STAFF REPORT: 4/12/23 REGULAR MEETING

APPLICATION NUMBER: 23-8277

ADDRESS: 5021 TIREMAN (AKA THE BLUE BIRD INN)

SCOPE: DEMOLISH ADDITION, REHABILITATE ADDITION, REHABILITATE FACADE, ERECT WALL SIGN

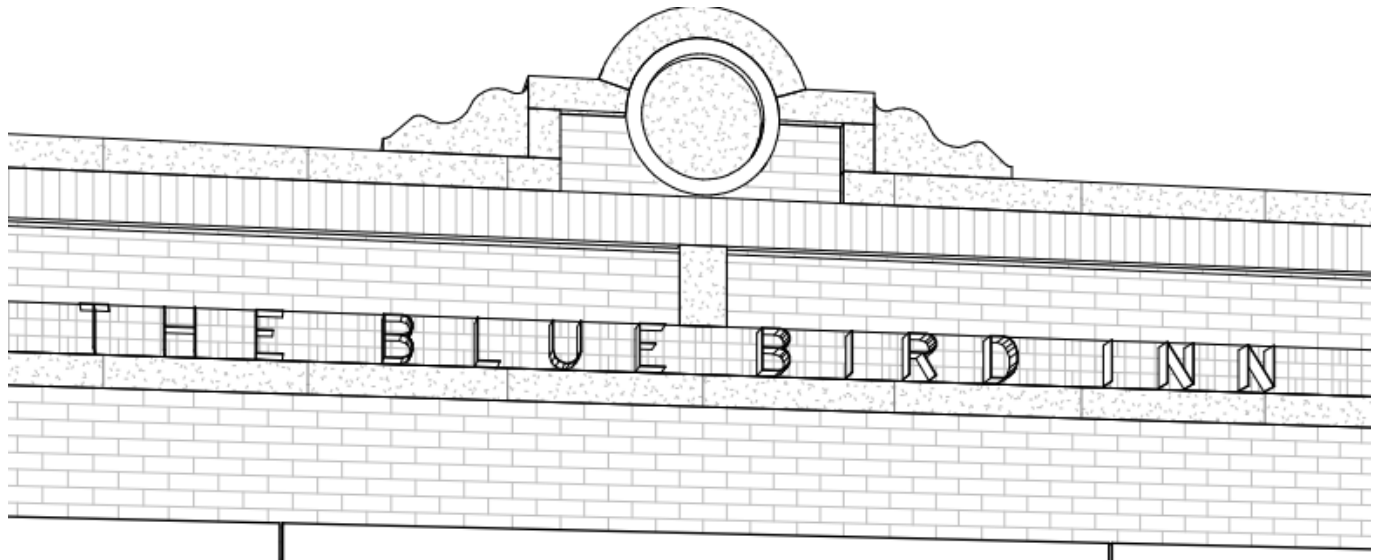
- The polychromatic brickwork on the front (north) façade is a significant feature, as described in detail in the Final Report and the Elements of Design, and should be preserved.
- Staff observes that the front facade brick and stone masonry units proposed for replacement on sheet A20 are indeed cracked or missing. The proposed replacement with historically appropriate materials, satisfying Standard #6: “Where the severity of deterioration requires replacement of a distinctive feature, the new feature shall match the old in design, color, texture, and other visual qualities and, where possible, materials” is appropriate.
- The west elevation and chimney are composed of common brick not apparently intended to be highly visible due to adjacent buildings; they are not character-defining features.

- Sheet S300 of the submitted drawings shows significant destructive probing including the removal of five courses of brick and unspecified amounts of the stucco veneer “for structural inspection.” This is not appropriate; Standard #7 directs “physical treatments ... will be undertaken using the gentlest means possible.” Less invasive means of examining the underlying structure should be explored before any destructive interventions are considered.
- The number and locations of bricks to be removed on the west elevation, south elevation, and chimney are not specified.

- The removal of any bricks or masonry elements beyond those specified on sheet A20 of the application materials shall be subject to approval by staff.
- The brick veneer to be used on the addition shall be subject to approval by staff.
- Stucco veneer and mural rehabilitation shall be limited to filling existing cracks and voids and repainting with the existing color or colors. Existing material shall not be removed and the painted figures must not be disturbed.
- The final design of the proposed LED “neon” sign, including its color and the locations of its anchors, electrical penetrations, and other supporting elements, shall be subject to approval by staff.
- A full scope of work, subject to approval by staff, shall be provided before any work on the canopy is performed.

Entrance canopy. Image from application.

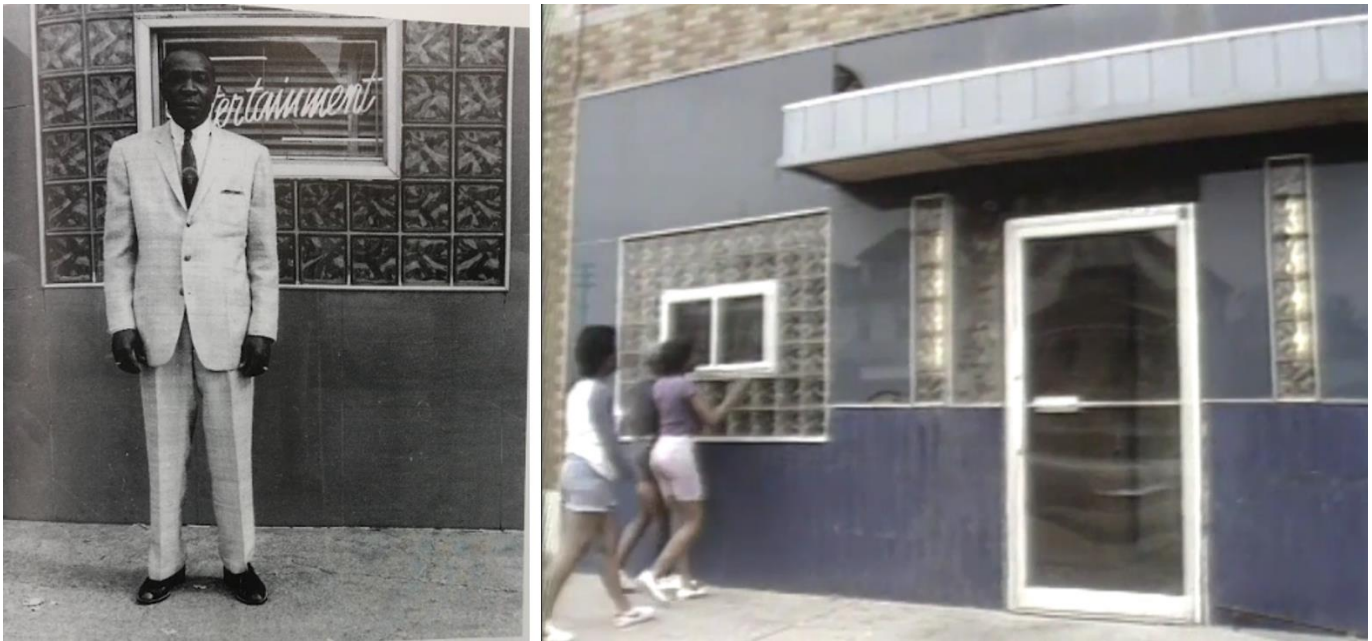
- Particular care must be taken regarding any work performed on the entrance canopy, as it is a highly visible and character-defining component of the façade. As discussed in the Final Report, its presence expresses the history of the building and reflects its 1944 transition from a commercial building into a jazz club. Further, it is composed of materials that are likely to be difficult or impossible to replace if damaged. Any inspection of the canopy should be as noninvasive as possible and any rehabilitation work should make every effort to retain existing materials. Any change to the materials or appearance of the canopy would constitute a “removal of distinctive materials or alteration of features ... [to] be avoided” (Standard #2).

- The application does not include a plan or section of the proposed LED sign.
- The application does not include a detailed scope of work for the canopy rehabilitation.
